Alfred Street Precinct (PP-2020-74)  
Planning Proposals - Gateway Implementation  
Department of Planning, Industry, and Environment  
Locked Bag 5022  
PARRAMATTA NSW 2124  
<https://pp.planningportal.nsw.gov.au/ppr/under-exhibition/alfred-street-precinct>

Submission on the Alfred Street Precinct Planning Proposal (PP-2020-74)

Tract Consultants Pty Ltd has been engaged by the Owners Corporation representing the owners of 263 - 269 Alfred Street (SP71563) and 4 Little Alfred Street (SP71454), and we are pleased to provide this submission regarding the Alfred Street Planning Proposal (PP-2020-74). Our client's land is identified as Site D within the planning proposal.

Figure 2. Applying 4:1 FSR to Site D – Alfred Street Massing Study (Source: AJ+C, 2021)

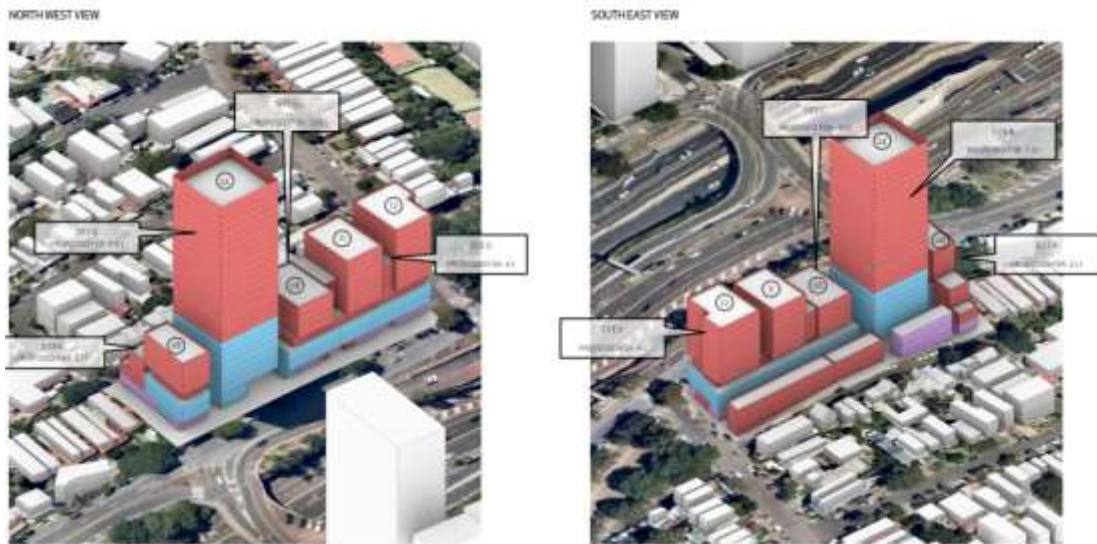
Our client strongly submits that the starting point for Site D's redevelopment must be a minimum FSR of 4.0:1. It is submitted further that an FSR of 4.5:1 would, in reality, represent an appropriate additional margin beyond the minimum base case better to encourage future site consolidation and the redevelopment of the sites.

The increase from 4.0:1 to 4.5:1 represents only one additional floor on the part of the site. To demonstrate this point, please refer to the enclosed concepts by AJ+C within their massing study.

To facilitate the required minimum feasible base case FSR of 4.0:1, the HOB required is to be a minimum of 39m. To ensure that Site D can be redeveloped at the optimally feasible FSR of 4.5:1, an additional floor should be allowed, increasing the overall HOB to 42m.

Figure 6. Indicative Reference Plans - Ground Level Layout & Vehicle Access (Source: AJ+C, 2021)

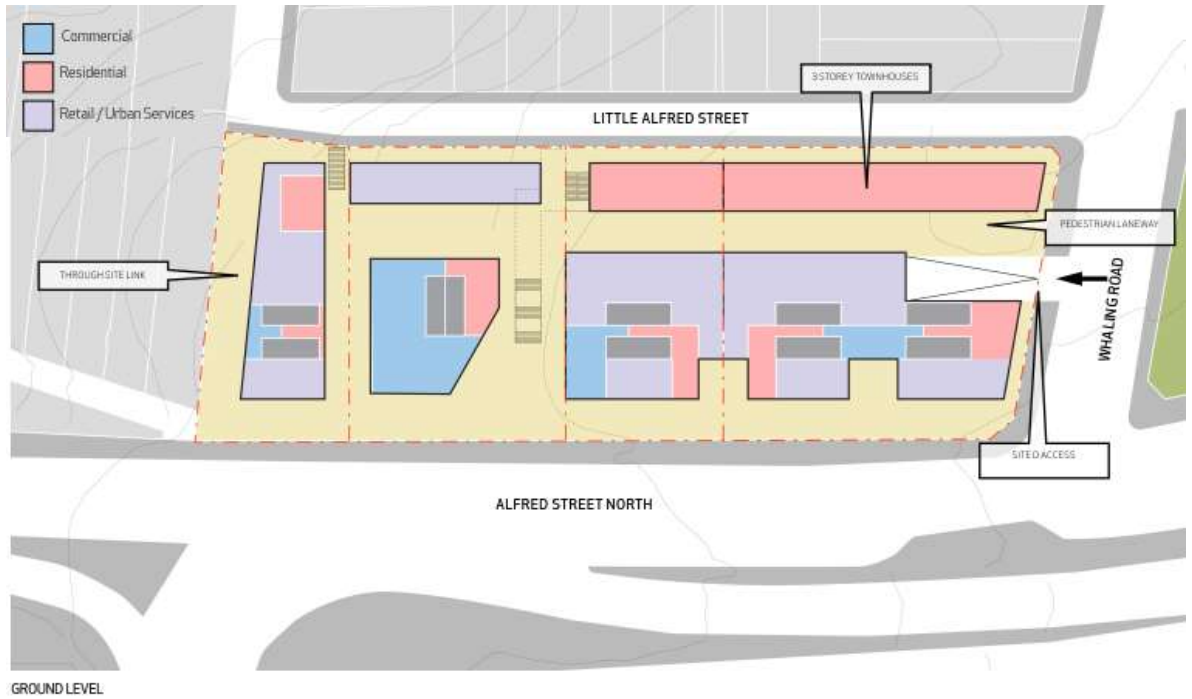
- AJ+C has designed the built form to deliver the vehicle access arrangements for each site separately as per the site-specific DCP. However, AJ+C remains of the view, notwithstanding the likelihood of RMS not supporting vehicle entry/exit to Alfred Street North, that a shared vehicle entry from Alfred Street North will result in a far superior urban design outcome across the Precinct because:

- It results in far more activated frontage along the internal pedestrian laneway;
  - Ensures vehicular entries do not dominate the park frontage;
  - It provides a safer pedestrian environment compared to a parallel ramp arrangement and loading to Little Alfred Street, and;

- The alternate arrangement of a left in - left out vehicular entry on Alfred Street North does not increase traffic numbers.
- Overshadowing of the park in terms of the building height in Site D, is minimised by sharing the built form height over two cores. The result of which creates, in AJ+C's view, a superior built form composition compared to a fragmented option with a higher building height on the northern core of Site D; and

The DCP prepared as part of the Planning Proposal initially proposed to provide access to Site C through Site B. In the last revision of documents, access to Site C now appears to be through Site D.

Respectfully, we submit that access to each of the Alfred Street Precinct sites within the precinct should be available independently from the other as per existing conditions, consequently enabling individual redevelopment if required.
